Pasi Vaananen
Systems Architect
Embedded Computing

As a manufacturer of both AC and DC powered server category equipment, many of which can be qualified under EPA Energy Star requirements for "Blade Systems", we have reviewed the present draft (Draft version 4) of the specification and associated set of normative documents.

Clarifications needed for the tests for Blade Systems with distributed powering architectures

Figure 2 – Distributed DC powering architecture in Bladed System

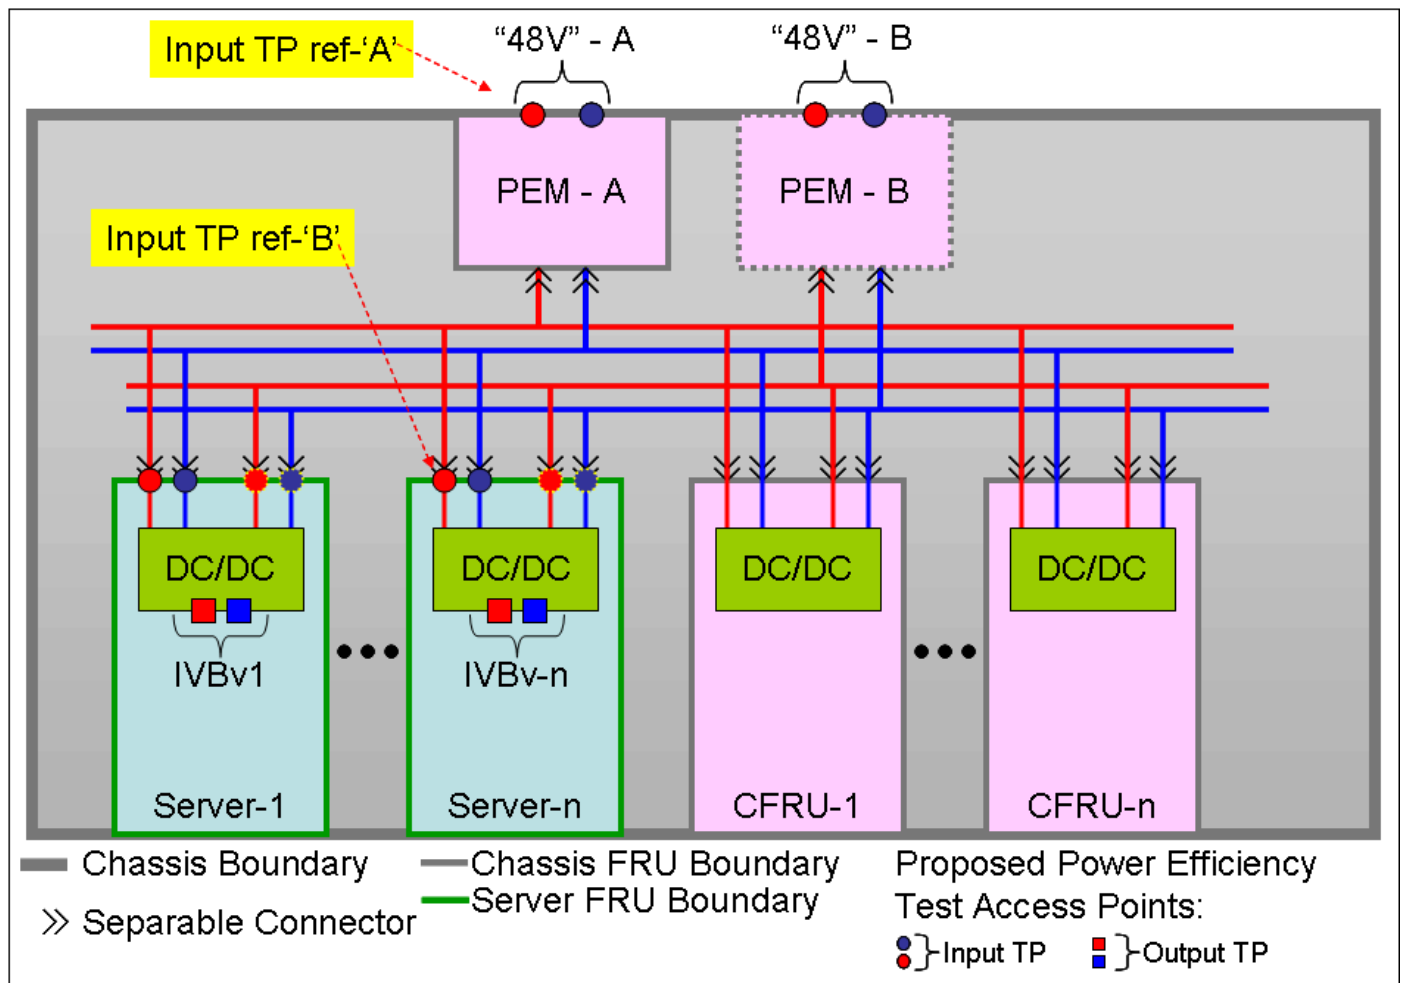
- There are two potential input test access points: equipment input (points in PEM in Figure 2, above), and “Bladed Server” FRU inputs. EPA should clarify whether the converter needs to be tested from equipment input (reference point ‘A’), or “Blade Server” input (reference point ‘B’). It would be significantly simpler to test from reference point ‘B’, and we would therefore prefer this to be specified as reference point.

- If EPA decides that the distributed converters MUST be tested from the input reference point ‘A’, then EPA needs to clarify that all other loads than the converter under test are to be disconnected from the system prior to the test. Otherwise, it is impossible to meaningfully determine the efficiency of the converter under test.

- EPA should clarify the test procedure for equipment supporting redundant power feeds. We suggest that the efficiency testing for the redundant, distributed powering architecture should be only mandated with only one power feed active, as this represents the worst case. Testing with two active feeds should be left optional.

- As briefly described above, the converters in “Blade Servers” may be equivalent or different. EPA should clarify that the particular power converter needs to be tested only once, even if used in differing “Blade Server” designs. This is essentially equivalent to how the converters in the centralized architecture are tested, with the exception that if different converters are used, each configuration needs to be independently tested.

- In addition to distributed converters on “Blade Servers”, there are typically additional converters hosted within “Blade Chassis” FRUs, such as in fan modules, management modules, etc. EPA should clarify if these converters need to be also independently tested for efficiency, and if EPA requires them to be independently tested, we suggest that EPA would limit the efficiency requirements to apply to only converters over some prescribed wattage (such as 20W) to reduce the associated test effort needed. Depending on a design, there may be quite many small converters to support powering of management infrastructure, which do not consume much power in the context of the overall “Blade System”, and are not easily accessible for testing as they typically constitute of components directly soldered to FRU PCBs. As the efficiency of these small converters does not represent major energy efficiency improvement opportunity, testing of such converters should be exempted from the requirements.

- There is no clearly defined accessible standard output test access points for efficiency testing of the distributed converters associated with the “Blade Servers” on distributed conversion architecture, as these converters are typically not designed as FRUs. However, nothing in this architecture would preclude the system to meet the power supply efficiency requirements specified by EPA if the test access can be accomplished. As such, EPA should clarify that the distributed converters can be tested according to the EPRI procedure, as long as the associated converter output(s) can be isolated from the “Blade Server” load for the purpose of testing, and the converter can be brought to its normal operation state using any accessible interface, as needed. The specific methods to accomplish this may include use of sockets, connectors, etc. but should be left out of the normative test procedure specification.
